## PETITION IN SUPPORT & MEMBER SUPPORT

APPLICATION No. **20/00411/DCH** APPLICATION DATE: 19/02/2020

LOCATION: 23 HEOL PANT-Y-RHYN, WHITCHURCH, CARDIFF, CF14  
7BZ

PROPOSAL: AMENDMENTS TO SCREENING ON LEFT AND RIGHT  
HAND SIDES OF BALCONY

## Revised Glass Balcony @ 23 Heol Pant Y Rhyn, Whitchurch, Cardiff

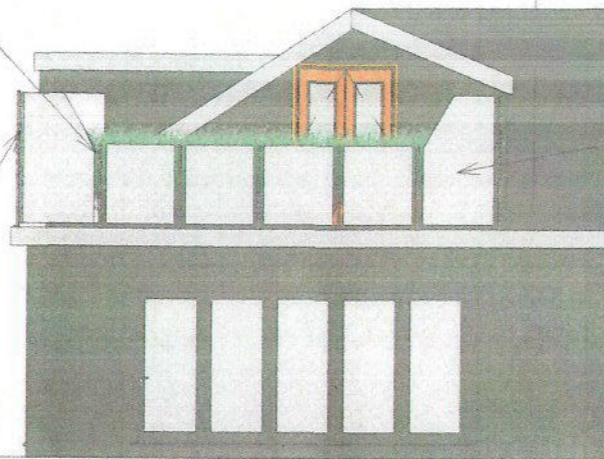
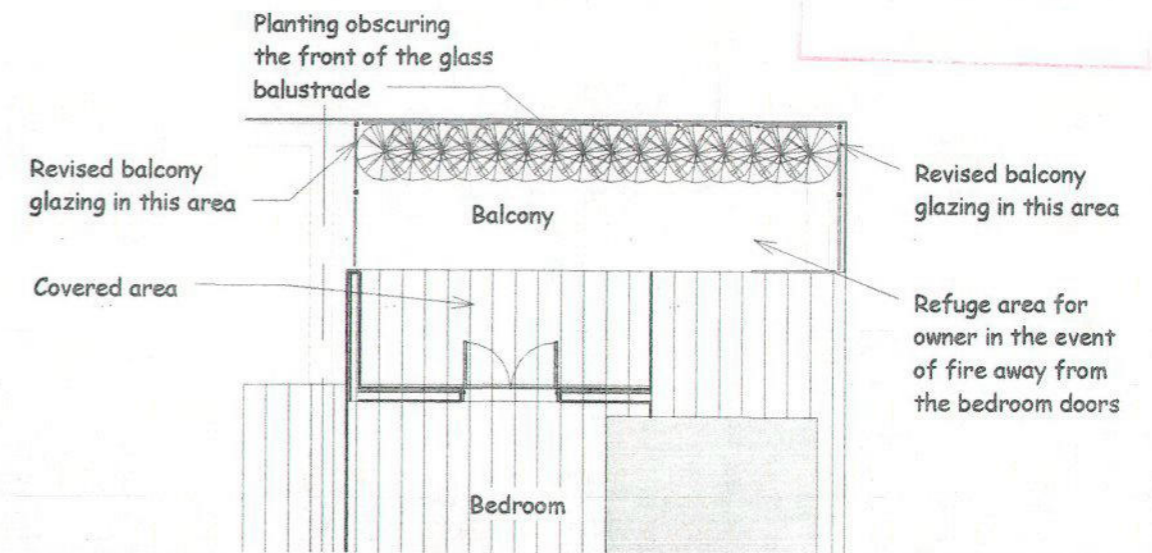
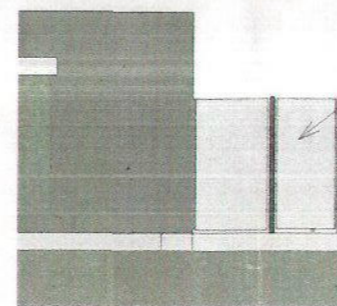
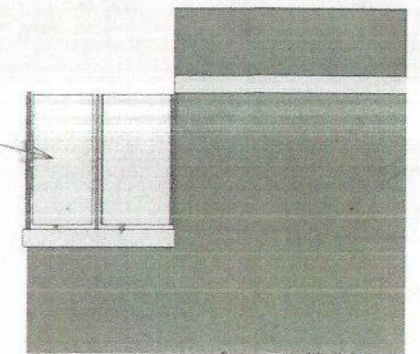
- 8.4 The additional height of the screening to the sides and at the corners of the front edge of the balcony/roof terrace will assist in preventing views to the side towards the neighbouring properties (Nos 21 & 25 Heol Pant Y Rhyn) when compared with the previous proposal, however, the usable floor area of the roof terrace remains as constructed. The floor area associated with the structure has not been altered to assist in seeking to reduce harm to the amenity of nearby neighbouring residents who live within close proximity to the roof terrace, contrary to the policy and guidance stated above.

- 8.5 While the introduction of the amended screening is noted, the increase in height and length of the screening will add to the scale of the development. The screening has not been set back from the edge of the roof and its resulting scale and prominence would represent an incongruous form of development harmful to the character of the area and neighbouring amenity, contrary to policy and guidance stated above.
